Public Input No. 360-NFPA 101-2024 [New Section after 3.3]

Committee: SAF-MEA

Figure A.7.2.1.2.2(b) Door Width — Egress Capacity with Permitted Obstructions. Egress Capacity Width Measurement with Boundary/Edge Effect Clearances

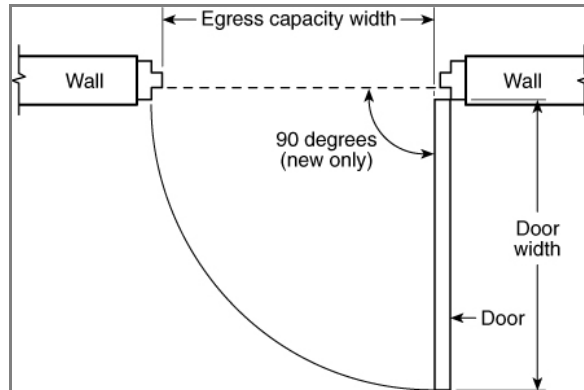
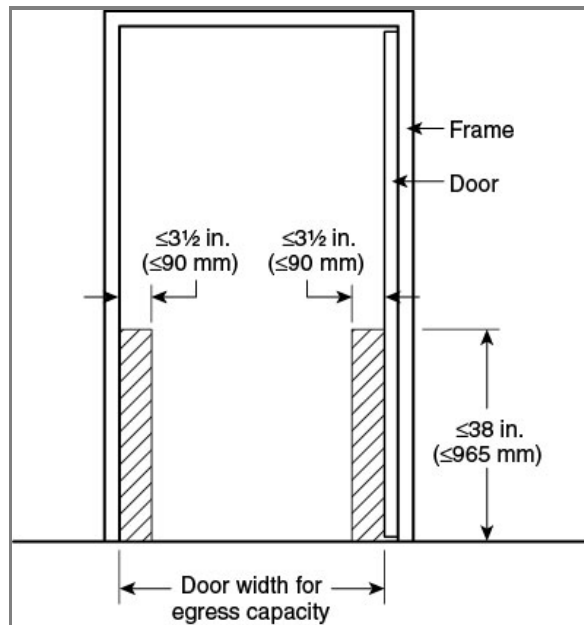
<<REPLACE FIGURE A.7.2.1.2.2(b) with ONE OF THE ATTACHED FIGURES>>

Existing Figure A.7.2.1.2.2(b) seems to allow for unspecified physical obstructions when measuring egress capacity widths of door openings, which creates confusion in the field. Unlike the 4-inch projection for fire exit hardware and panic hardware devices, these 3-1/2-inch encroachments at both sides of the door opening are not for tangible door hardware or other materials. Instead, they apply the effective-width concept of building elements such as corridors, ramps, stairs, and doors referred to as the boundary/edge effect described in NFPA 101. (See paragraphs 7.3.2.2, 7.3.3.2, and A.7.3.3.2.)

The first paragraph in A.7.3.3.2 includes the following statement: "In essence, the effective width phenomenon recognizes that there is an edge or boundary effect at the sides of a circulation path..." The unspecified projections shown in Figure A.7.2.1.2.2(b) illustrate the boundary/edge effect as it pertains to door openings.

Adopting one of the submitted figures (or a version thereof) to replace the existing figure clarifies the Code's intent.

Resolution: The related base paragraph refers to 3-1/2 in. projections, which can be physical projections into the door opening on both sides for the purpose of determining egress capacity. The concept of boundary/edge effect does not directly correlate with that described in the current annex figure. The proposed figure might create more confusion.
